4. Z AMPLIFIER AND FOCUSING

PHILIPS 1982 Mod note
for PM 3262 family.

4.1. UNIT 7 (FOCUS UNIT) : /04 AFS.

For circuit diagram and lay-out of this circuit see figure below.

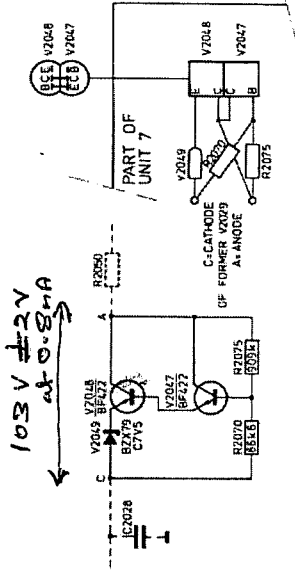
Replace neon stabilisation tube V 2029 by an electronic circuit consisting of 2 transistors V 2047, V 2048 (BF 422, 4822 130 44108), 1 zenerdiode BZX 79 C 7V5 (4822 130 30861) and 2 resistors 909 kohm (5322 116 54408) and 86,6 kohm (5322 116 54692).

This modification is necessary because the neon stabilisation tube will soon not be available. The modification can also be used in older instruments where V 2029 needs to be replaced.
